Our Ref: DOC18/74075
Your Ref: MP10_160 – Stage 2 MOD 6

Re: White Rock Wind Farm project - Modification Proposal MP10_0160 MOD 6

Attachment 1: Detailed OEH Comments – Modification to the White Rock Wind Farm project (MP10_0160 MOD 6)

Figure 2.1 WRWF Indicative Stage 2 layout

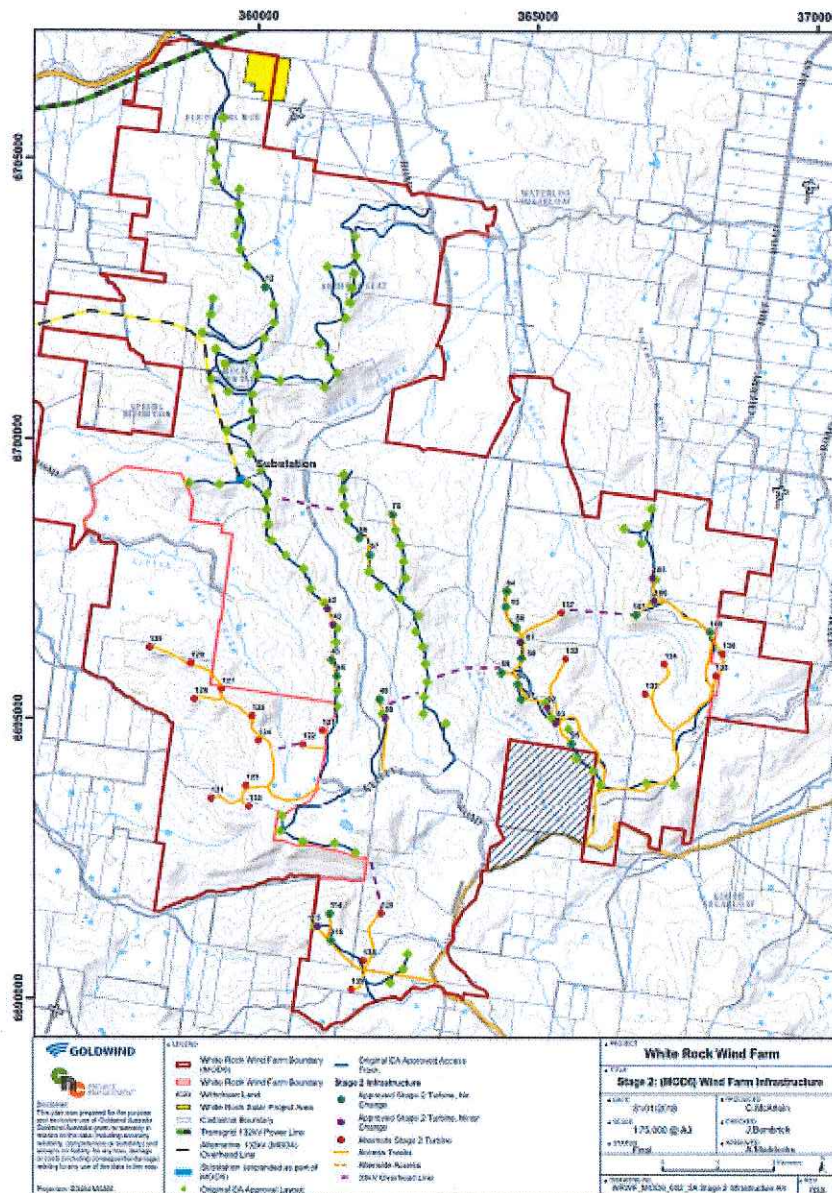
Comparison of the original Wind Farm layout and the proposed modification reveals a large change in development footprint, as set out in the map below, which shows the new locations for Stage 2 turbines (red dots) and tracks (connecting yellow lines). Turbines 121 through to 130 are in new locations in the western area of the subject site, as are Turbines 132, 133, 134, 135, 136, 137 in the eastern part of the site and Turbines 120, 138 and 139 in the south.

Although the number of turbines has not increased, the area of operation has been considerably expanded eastward and westward. In addition, the native vegetation clearing due to the new turbine locations, associated infrastructure and engineering details is over 220% greater than was originally approved. The increase is reportedly due to the original impact calculations under-estimating the impacts of tracks with the associated cut and fill and batter structures on steep slopes.
